LOCAL HISTORIC DISTRICT: Wilmore

ADDRESS OF PROPERTY: 1716 Wickford Place

SUMMARY OF REQUEST: Window/Door Replacement

Charlotte Historic District Commission - Case 2013-182

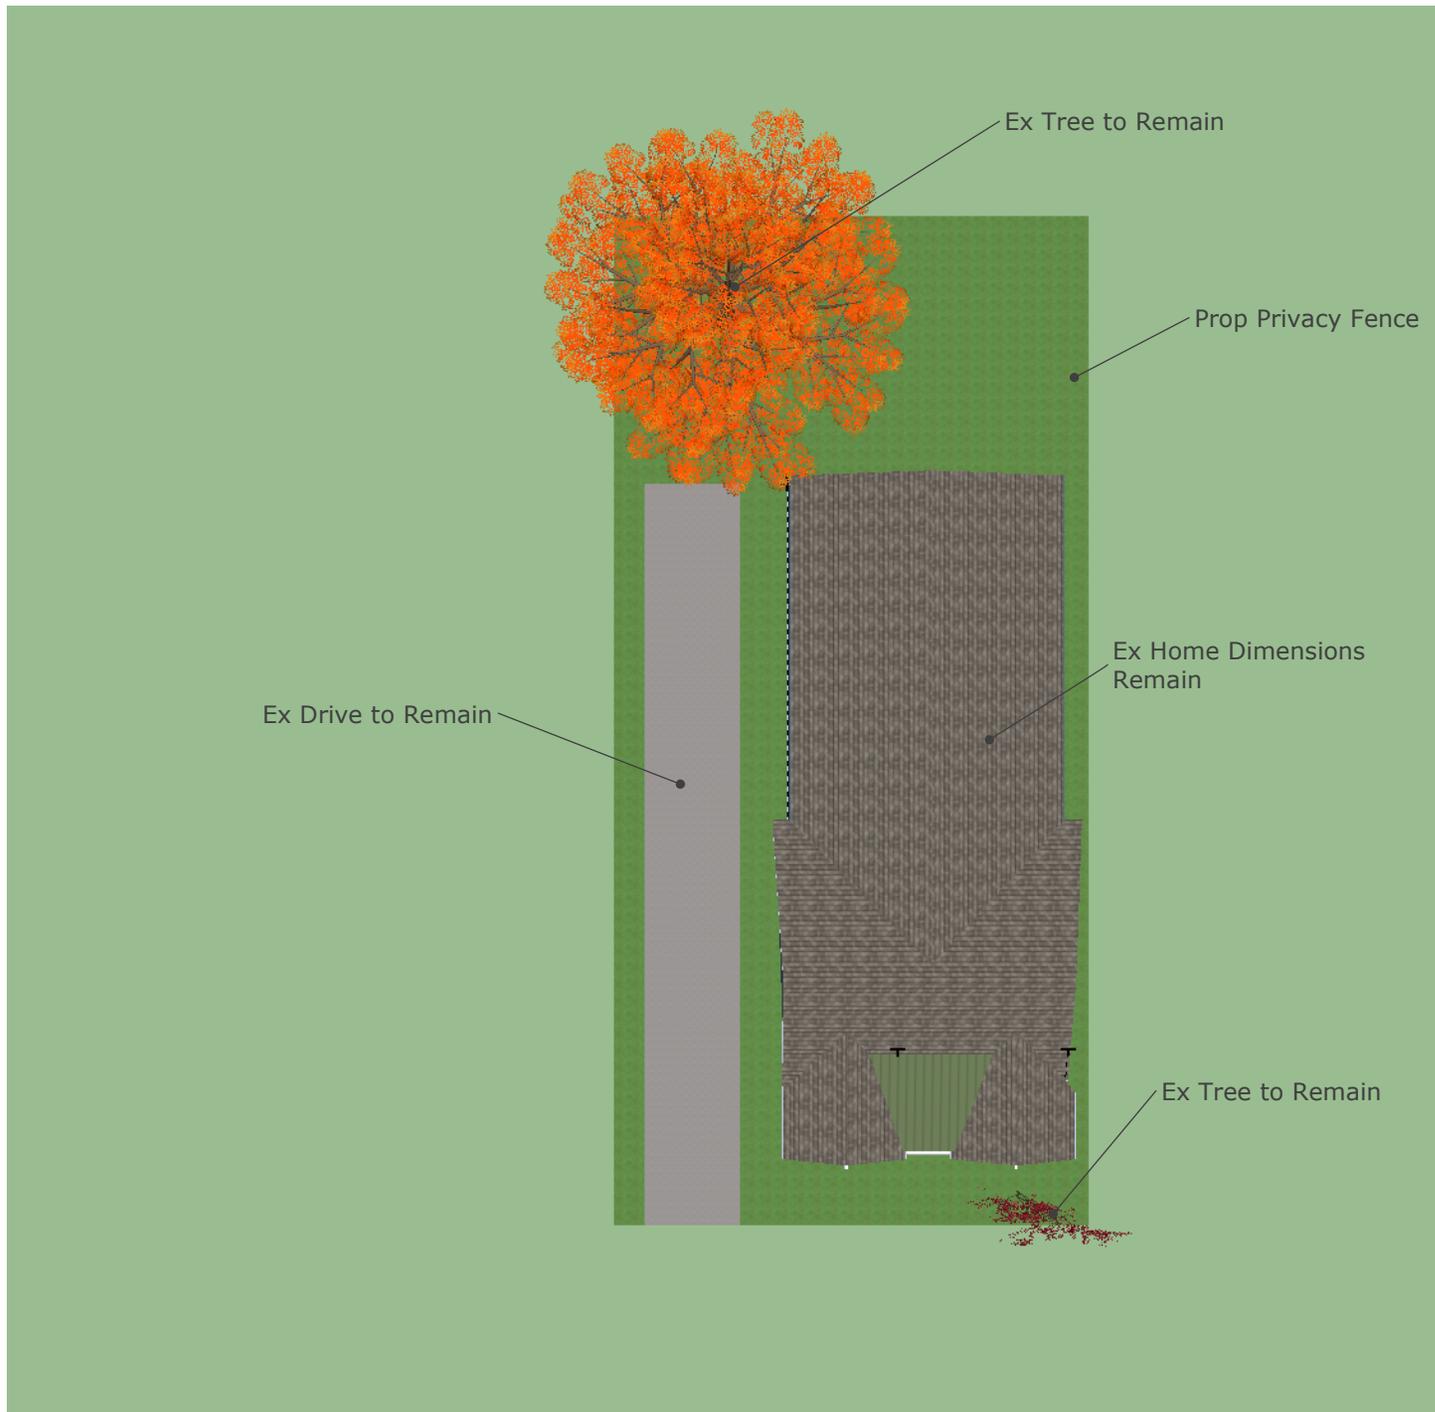
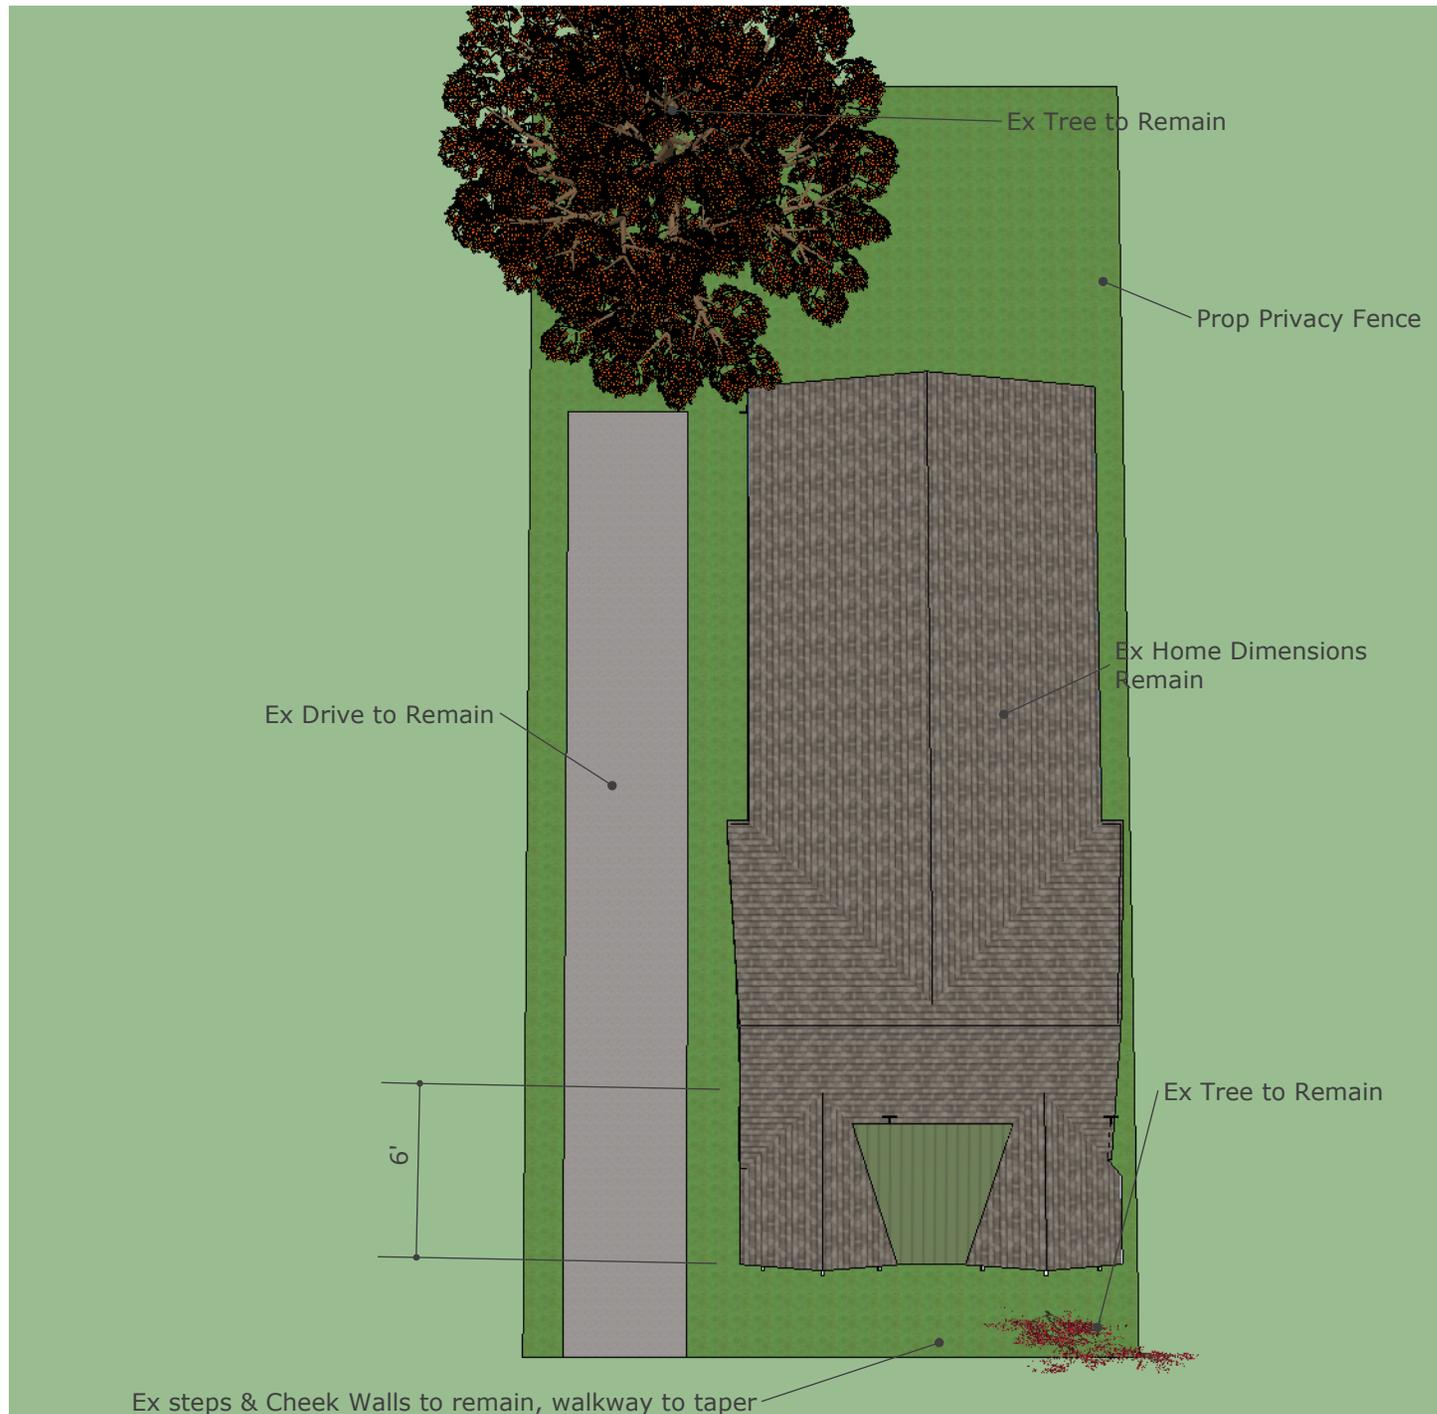
The proposal is a conversion of the dwelling to a single family home. Changes to the façade include removal of the front doors, replaced by a single main entrance, replacement of existing windows with two sets of paired windows and the addition of a sloped roof that will join the twin gables. The metal supports will be replaced by a traditional porch with a brick base and tapered columns. Siding will be replaced where needed to match the existing wood lap siding. The foundation will be painted and new brick steps will replace existing.

Staff believes the project meets the Guidelines for Additions.
